**TECHNICAL SPECIFICATION FOR
BLOWER MCC**

PROJECT: 1X800MW KRISHNAPATNAM

CUSTOMER: APGENCO

SPEC REF NO.: EP-BLW-KRP-01 REV 00

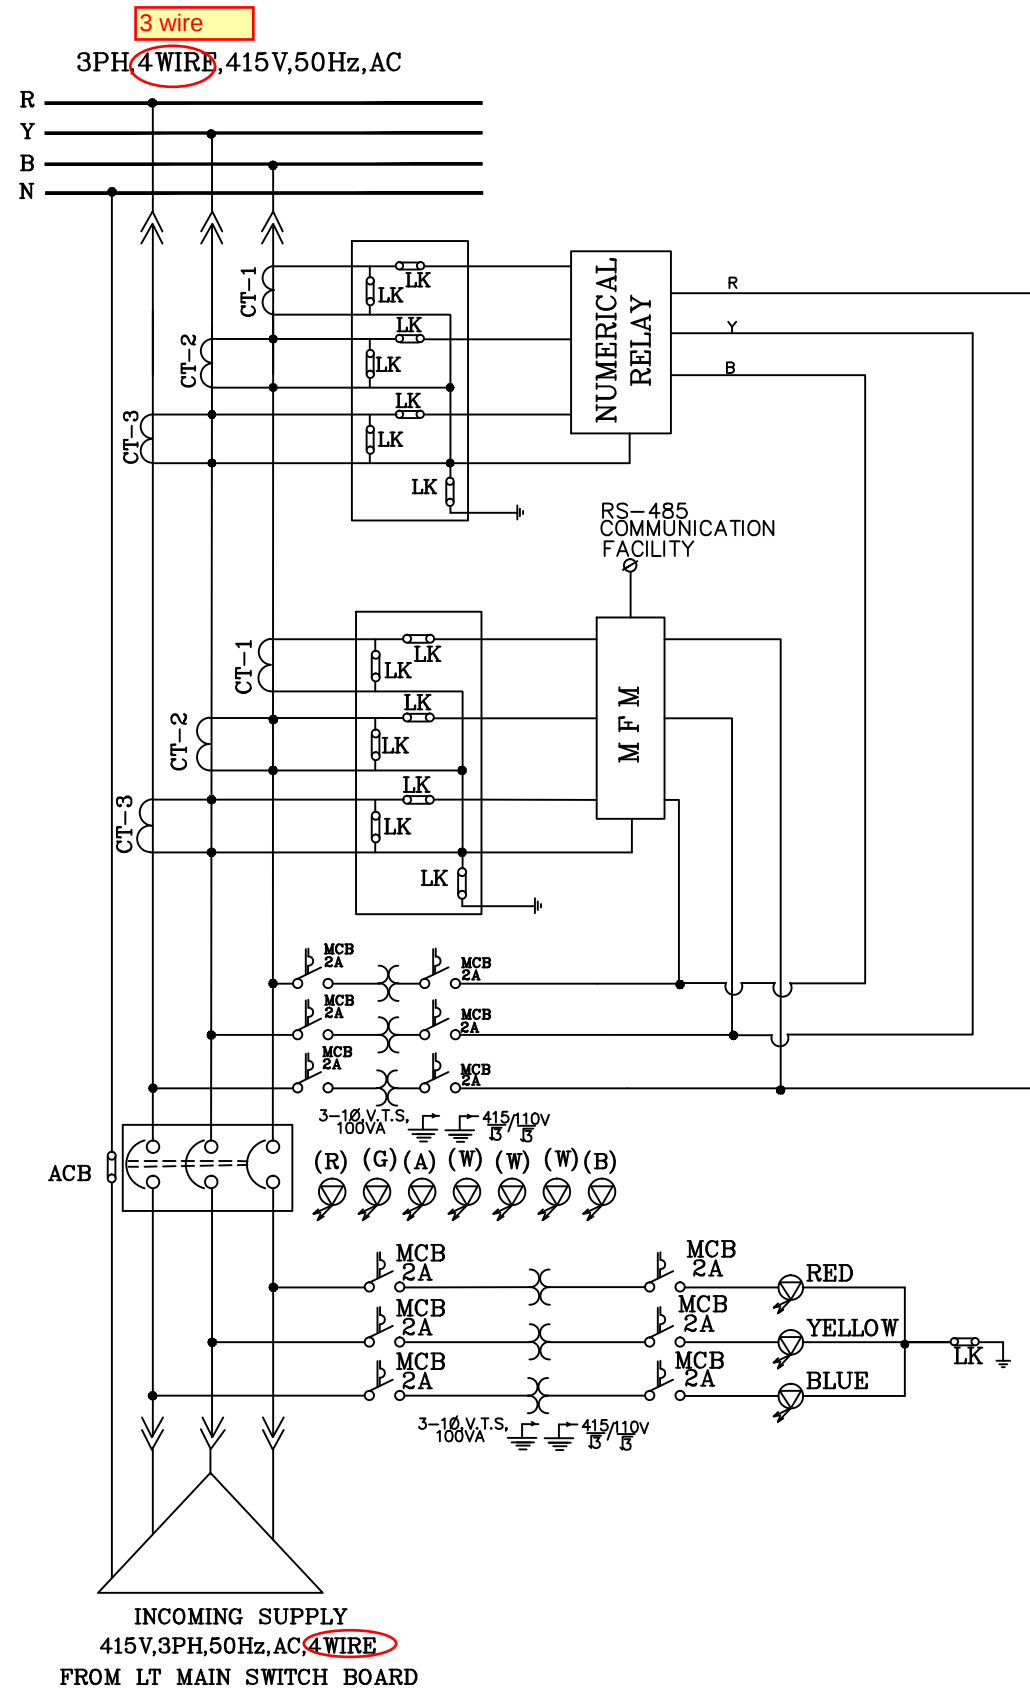
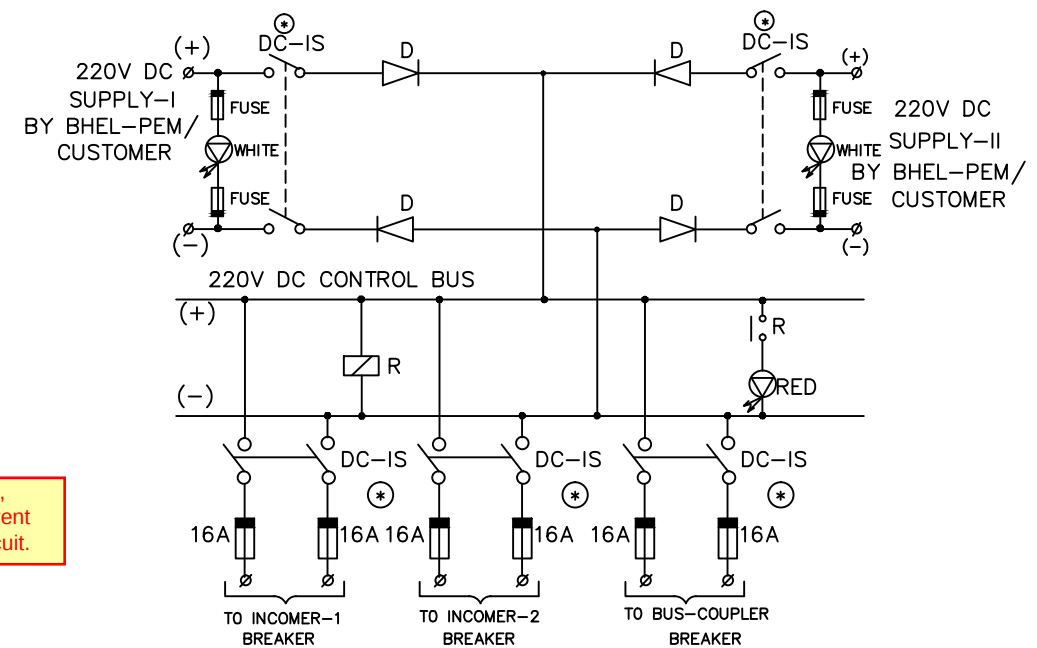
Incomer will be 3 wire as per earlier confirmation

BHEL shall indicate Ammeter, ammeter selector switch, current transducer in the incomer circuit.

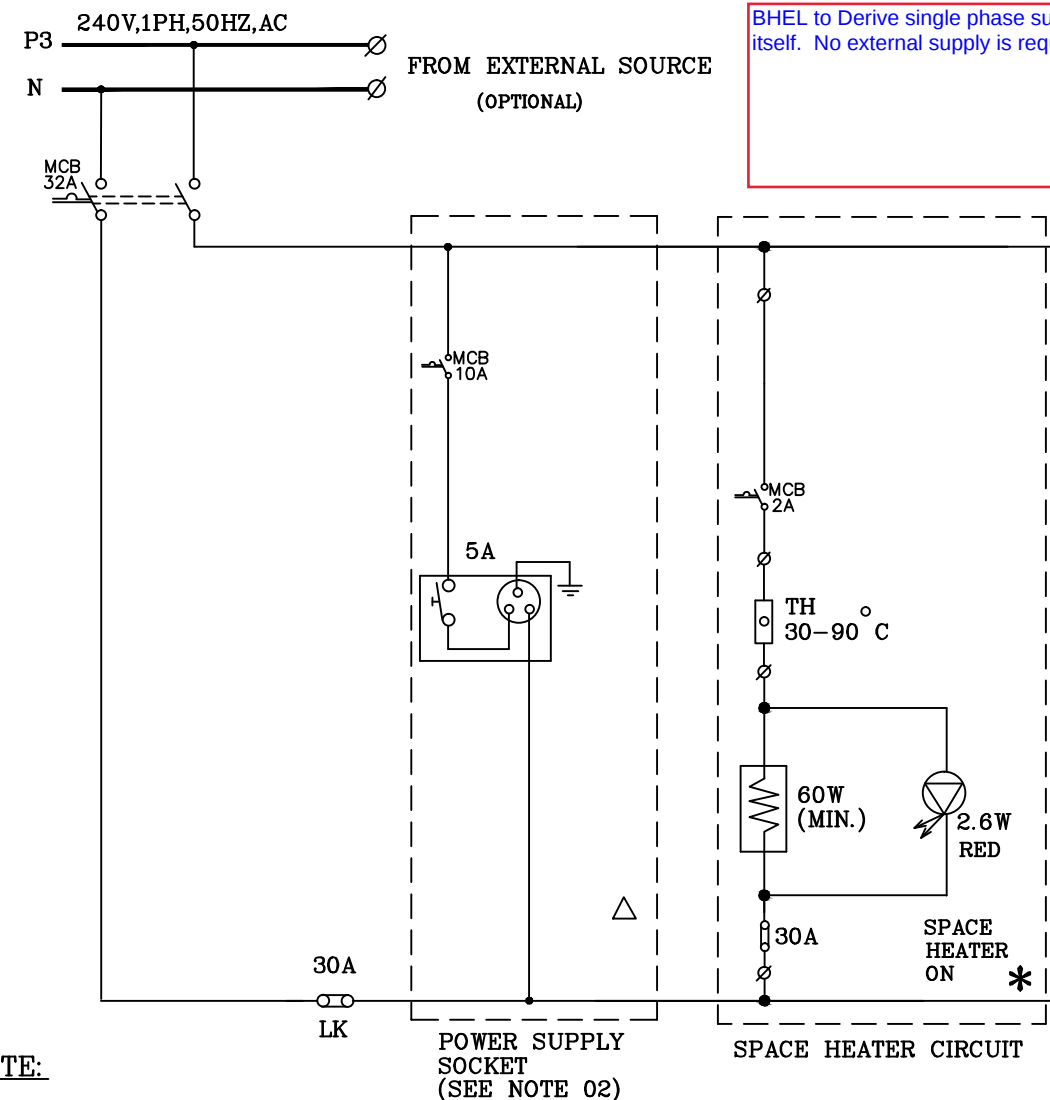
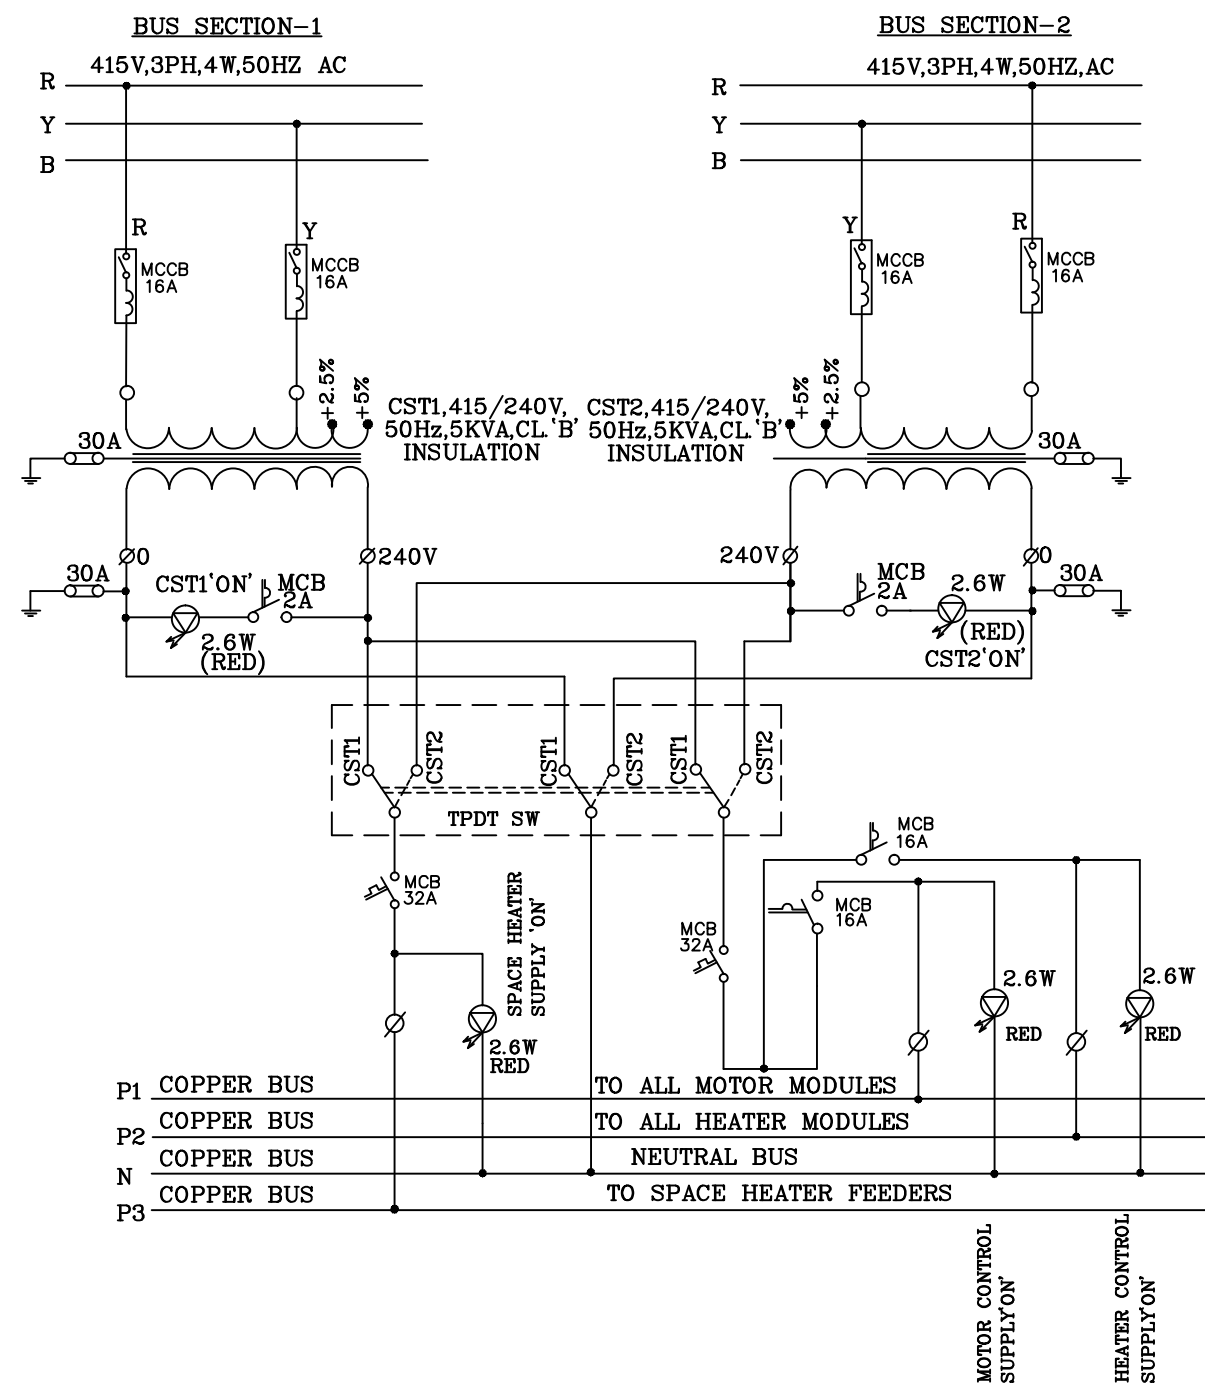
BHEL to Derive single phase supply from the Board itself. No external supply is required

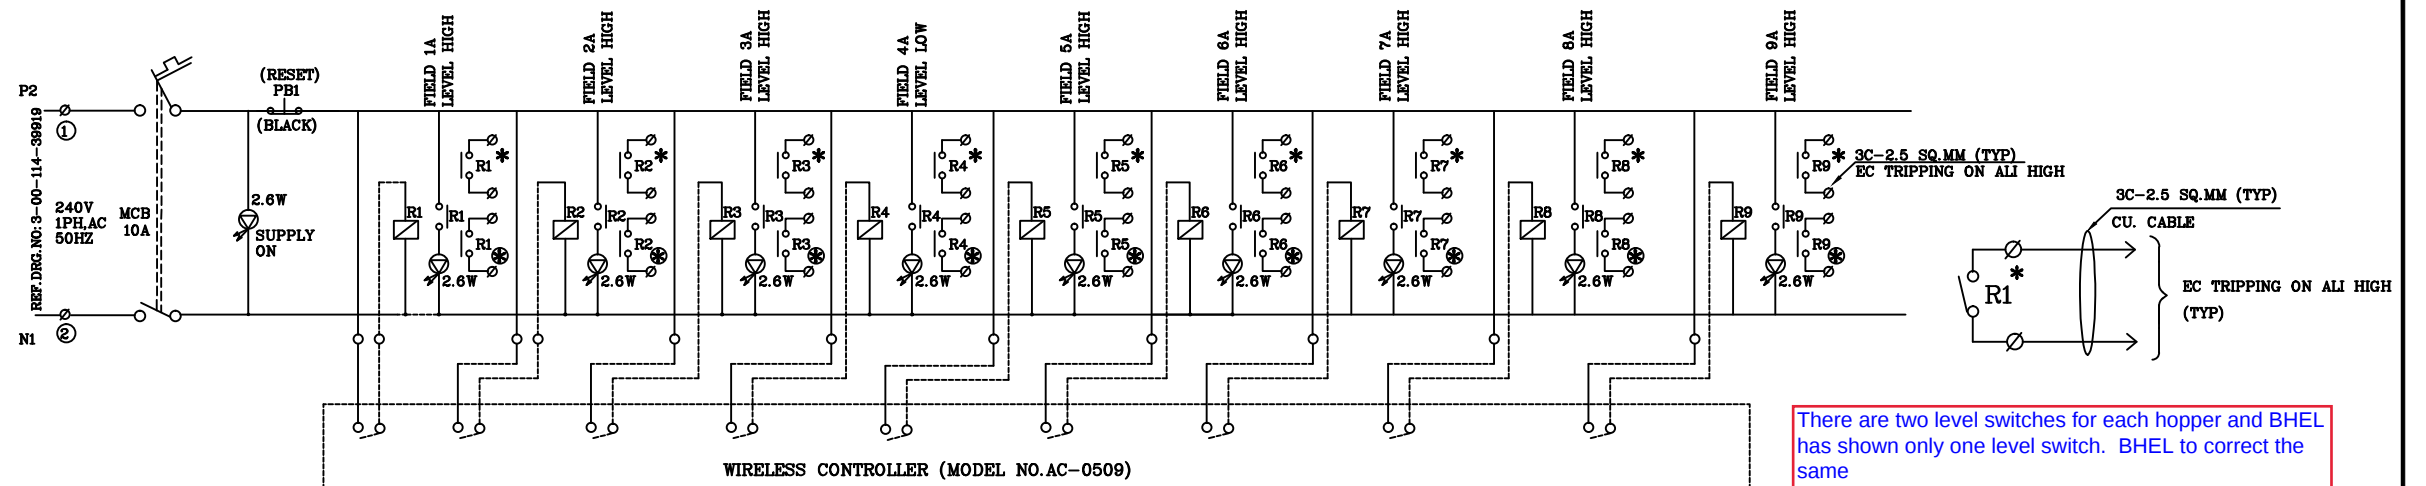
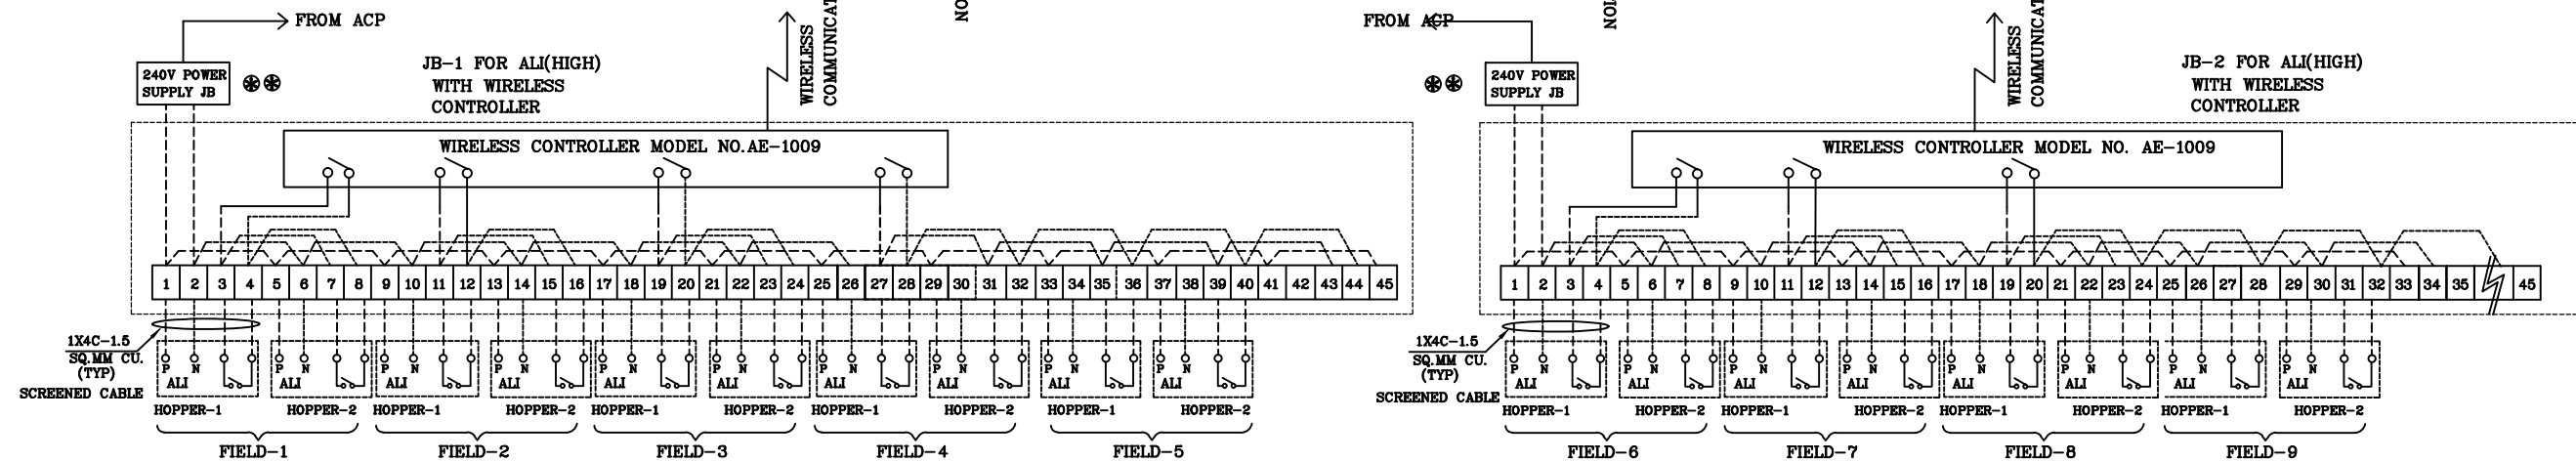
There are two level switches for each hopper and BHEL has shown only one level switch. BHEL to correct the same
